Access Compliance Report Public Rights-of-Way (Curb Ramps)

Intersection ID: 28310	Main Street: ARDREY_KELL_RD	Cross Street: WADE_ARDREY_RD	Location: NW
ADA ID: 6A0BE7922919	Ramp Type: PerpDiag	Initial Pass/Fail: Pass	Overall Compliance: No Severity Score: 7.5

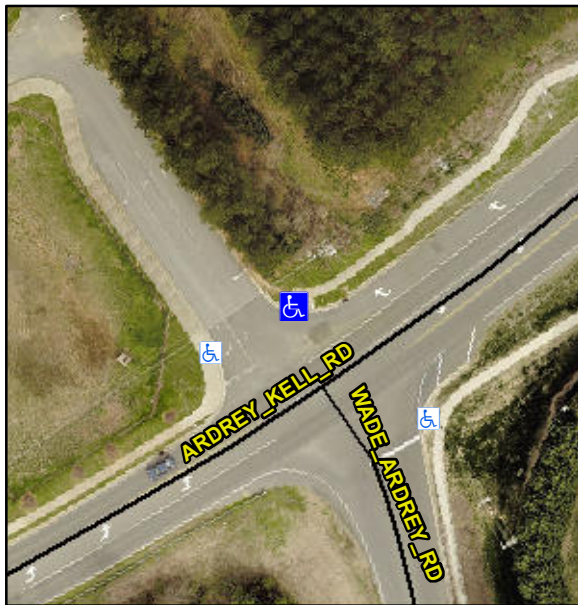
Not Found, R305.1.4, R304.5.4

Compliance	Description	Data	Compliance	Description	Data
N/A	Ramp Length (in)	71.0	Yes	Ramp Slope (%)	6.7
Yes	Ramp Width (in)	58.0	Yes	Ramp XSlope (%)	0.5
N/A	Flare Type LT	Sloped	N/A	Flare Type RT	N/A
N/A	Flare Slope LT (%)	9.5	Yes	Flare Slope RT (%)	5.0
N/A	Flare Traversable LT?	No	N/A	Flare Traversable RT?	Yes
Yes	Landing Length (in)	60.0	Yes	DWS Provided?	Yes
Yes	Landing Width (in)	58.0	Yes	DWS Contrast?	Yes
Yes	Landing Slope (%)	1.3	Yes	DWS Length (in)	25.5
Yes	Landing X Slope (%)	0.3	No	DWS Full Width?	No
N/A	Landing Curb? (Y/N)	No	Yes	DWS Offset (in)	2.0
N/A	Shared Landing?	No			
Yes	Gutter Ponding?	No	No	Gutter Slope (%)	6.5
Yes	Gutter Lip Ht (in)	0.0	Yes	Gutter X Slope (%)	2.0
N/A	Painted X Walk1?	No	N/A	Painted X Walk2?	No
	X Walk 1 Direction	To SW		X Walk 2 Direction	To SE
N/A	X Walk 1 Width (in)	N/A	N/A	X Walk 2 Width (in)	N/A
	X Walk 1 Slope (%)	0.3		X Walk 2 Slope (%)	0.7
	X Walk 1 X Slope (%)	1.7		X Walk 2 X Slope (%)	2.1

N/A	Ramp inside XWalk1?	N/A	N/A	Ramp inside XWalk2?	N/A
	Road Slope (%)	2.4	N/A	Clear Space?	Yes
	Road X Slope (%)	1.2	N/A	Clear Space to XWalk (in)	N/A
Yes	Any Obstructions?	No	Yes	Storm Grate/Utility Hazard?	No
	Obstruction Type			Storm Grate/Utility Type	
			N/A		N/A
			Yes	Surface Condition? (G/P)	Good

Remove & Replace Curb Ramp With Two New Directional Ramps or Equivalent. Remove & Replace Gutter.
